**City of Portland, Maine – Building or Use Permit Application** 389 Congress Street, 04101, Tel: (207) 874-8703, FAX: 874-8716

Location of Construction: 15 Merriam St, Peaks Island		Owner: Weymouth, Lawrence & Anne		Phone:		Permit No: <b>971126</b>
Owner Address: SAA 04108		Lessee/Buyer's Name:		Phone: 774-1067		
Contractor Name: Rob deSousa		Address: 766-2920		Phone:		Zoning Approval: <i>OK with conditions</i> <b>Special Zone or Reviews:</b> <input type="checkbox"/> Shoreland <i>was 10/14/97</i> <input type="checkbox"/> Wetland <input type="checkbox"/> Flood Zone <input type="checkbox"/> Subdivision <i>14-427</i> <input type="checkbox"/> Site Plan <i>major</i> <input type="checkbox"/> minor <input type="checkbox"/> mm <input type="checkbox"/> <i>built in 1900's</i>
Past Use: 1-fam		Proposed Use: Same		COST OF WORK: \$ 7,000.00 PERMIT FEE: \$ 55.00 FIRE DEPT. <input type="checkbox"/> Approved <input type="checkbox"/> Denied INSPECTION: Use Group: Type: Signature: Signature:		
Proposed Project Description: Enclose porch Int Renovations				PEDESTRIAN ACTIVITIES DISTRICT (P.A.D.) Action: <input type="checkbox"/> Approved <input type="checkbox"/> Approved with Conditions <input type=

# AMENDMENT to Weymouth Building Permit.

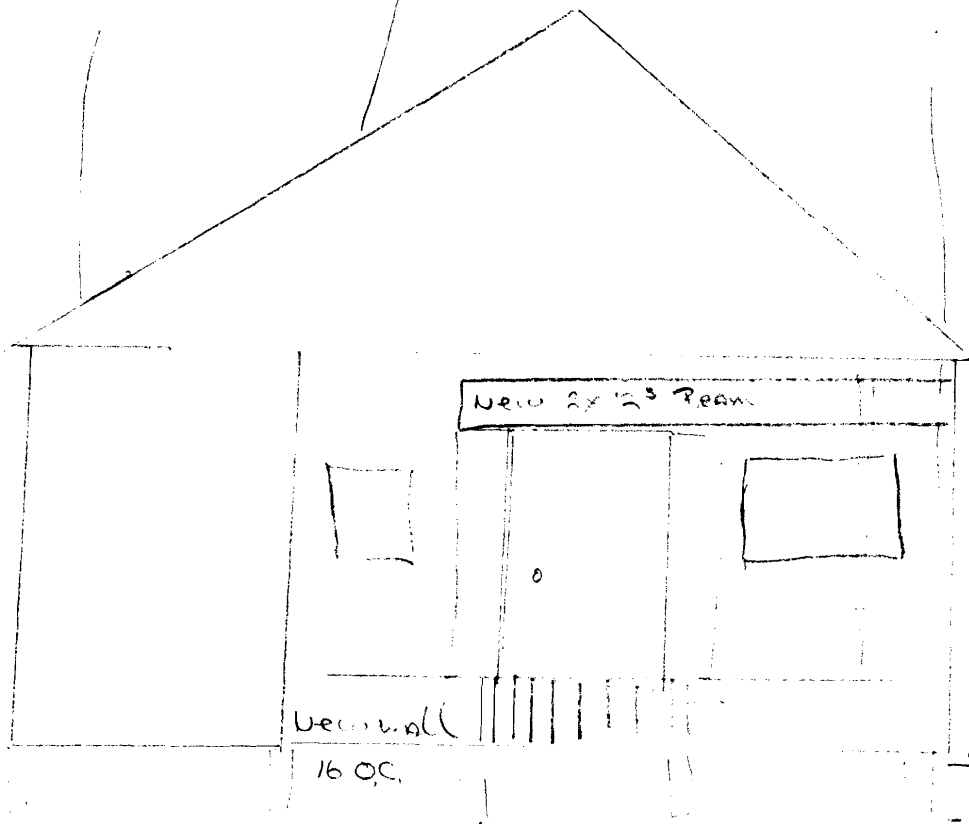
9. Other requirements of condition Any open porch existing with a roof over the same in June 5, 1957, and encroaching upon any yard required by this article may be enclosed if the major portion of the enclosure is of glass. (14-42)
